16-19 Gresse Street, London, W1

typical core lobby door to stair 01 detail section

job no.	drawing	rev.
0382 -A	A4211	D

1 door head & overpanel / soffit junction detail

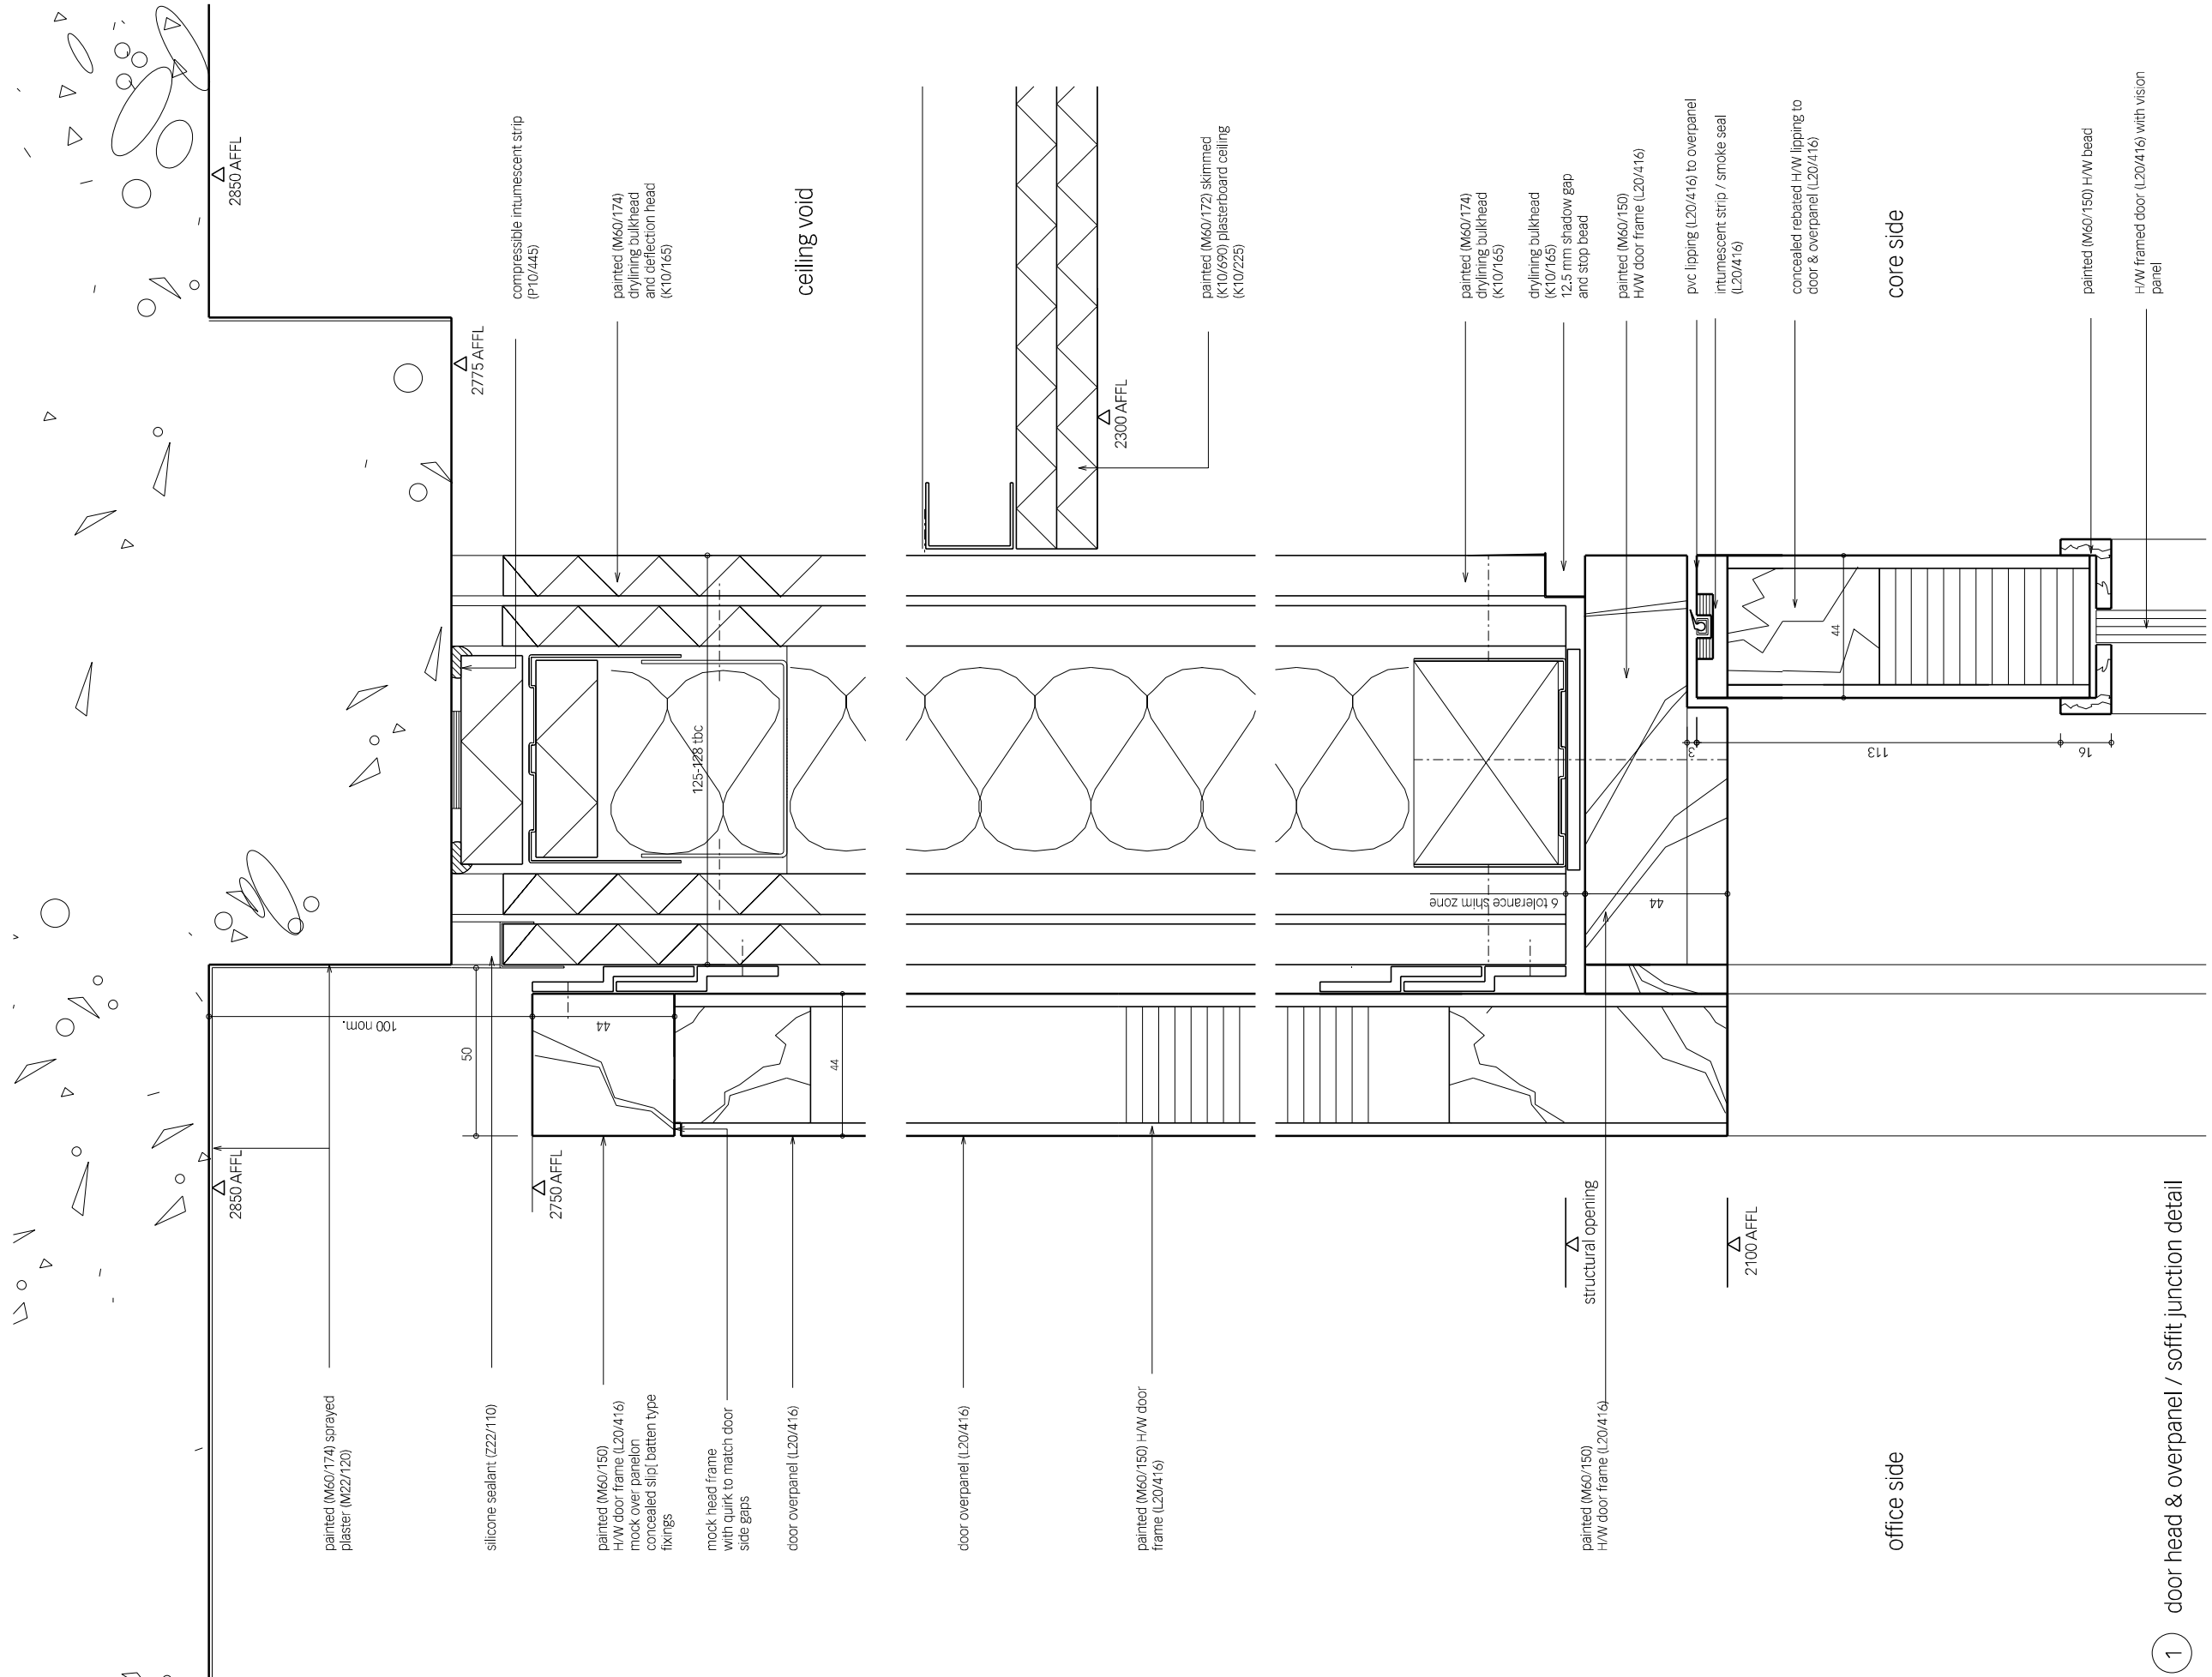
revisions	date	rev
pvc lipping to overpanel added, spec references added	23.06.06	A
Issued for construction.	23.07.07	B
overpanel detail revised to deal with revised concrete construction and Meica services redesign. Detail only applys to stair 1 lobby door.	14.03.08	C
overpanel detail revised to deal with separation of work packages and to have a proven fire rated PB construction at the door bulkhead/overpanel.	10.03.09	D
